#### REMARKS

The present amendment is made in response to the Office Action having a mailing date of March 28, 2000, which set a shortened three-month period for response, making this response due by June 28, 2000.

1 of 2

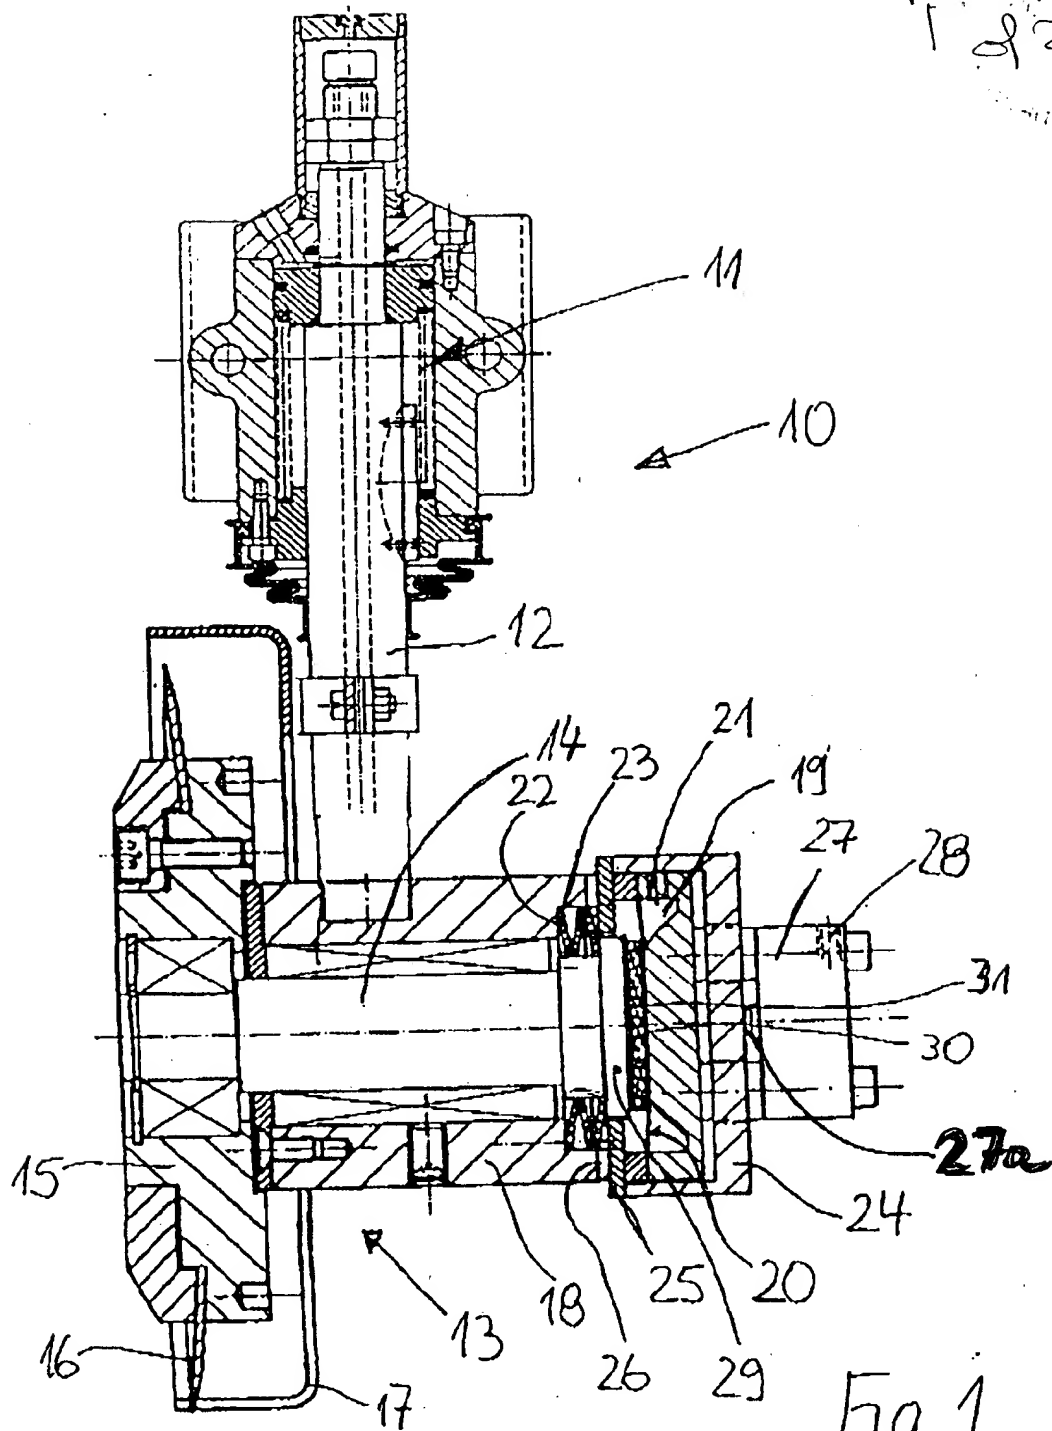
In the Office Action, the drawings were objected to for several informalities. Attached herewith are corrected Figures 1 and 2, with changes indicated in red ink,

which Applicant believes overcome these objections. More specifically, Figure 1 has been amended to include reference numeral 27a to indicate the portion of the piston in the space between 27 and 24. The specification has likewise been amended on page 9, at lines 6 and 9, to more clearly describe the preferred configuration on the pneumatic drive 27, as shown in Figure 1, with reference to 27a. Because these structures have already been disclosed in Figure 1, this amendment to the specification does not comprise new matter.
